TOPTEx SWEATERS LTD. (ANNEXE BUILDING)

10 April 2025

2. Observation:

Observation-03: Falling hazard and inadequate parapet height. (Factory Building)

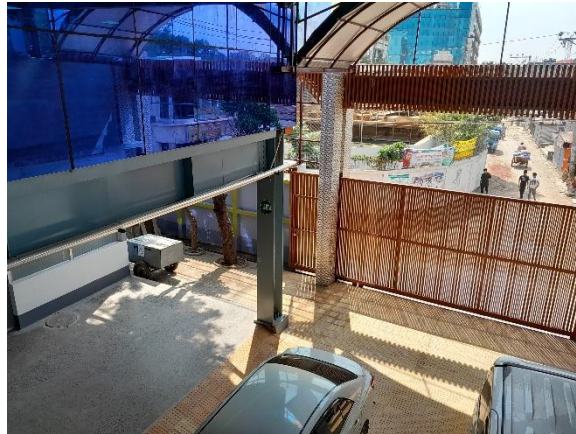
Description: Falling hazard at the stair zone and inadequate parapet height were observed (625 mm). Building engineer is required to increase the parapet height and take appropriate action to mitigate the falling hazard.

4.		Carry out the suggested remedial works if required.	within 6 months
5.	Falling hazard and inadequate parapet height. (Factory Building)	Building engineer is required to increase the parapet height following BNBC and take appropriate action to mitigate the falling hazard.	within 6 weeks

Observation-05: Column susceptible to vehicle impact. (Factory Building)

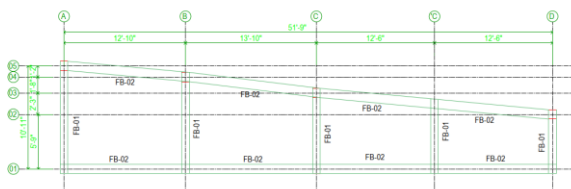
Description: Column on the ground floor is found susceptible to vehicle impact. Building engineer is required to provide vehicle impact protection on the column.

6.	Gaps in steel member connections. (Factory Building)	Building engineer is required to repair the gaps with a suitable method.	within 6 weeks
7.	Column susceptible to vehicle impact. (Factory Building)	Building engineer is required to provide vehicle impact protection on the column.	within 6 weeks
